RE: Additional Information Request
Lyons Quarry, Permit No. M-1977-208
Y22Q3 Groundwater Monitoring Report, C-Pit

On November 7, 2022, CEMEX received a letter from Division of Reclamation, Mining and Safety (DRMS) titled "AdditionalInfoNeeded_M1977208_3Q2022.pdf" related to our 2022 3rd Quarter Groundwater Monitoring Report. Below are CEMEX's response in *italic font* to items #1-3 in that letter:

Figure A Time trend plots for CEM-001

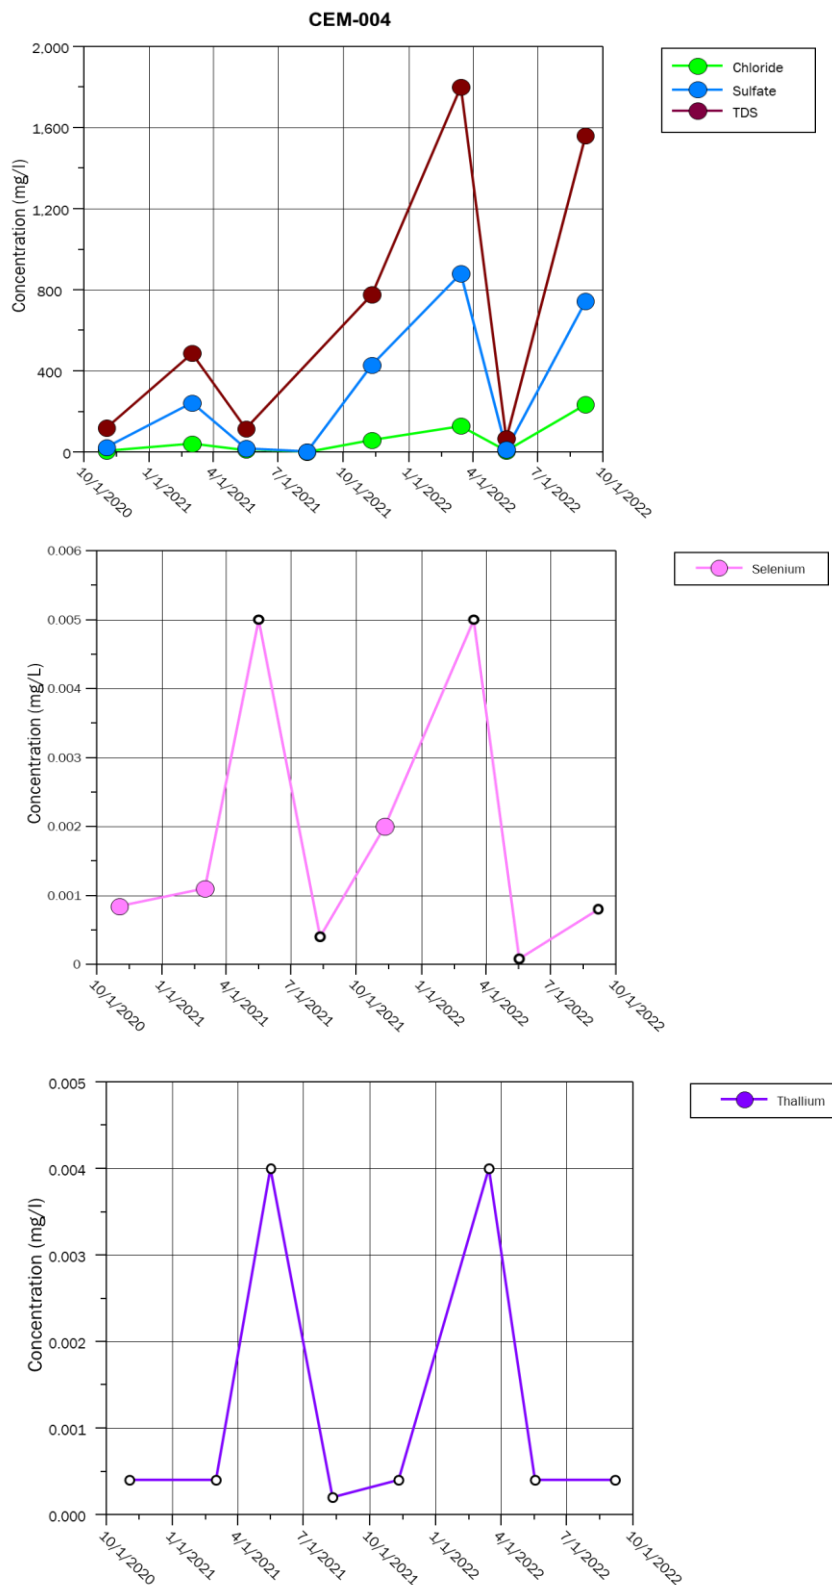
3. In the Operator's response to the Division's request for additional information, dated October 4, 2022, the Operator committed to providing graphs for analyte concentrations for each location that depict trends over the last eight (8) quarters. Provide graphs for analyte concentrations for each location that depict trends over the last eight (8) quarters.

Previous 8 quarters of analyte concentrations have been compiled and attached.
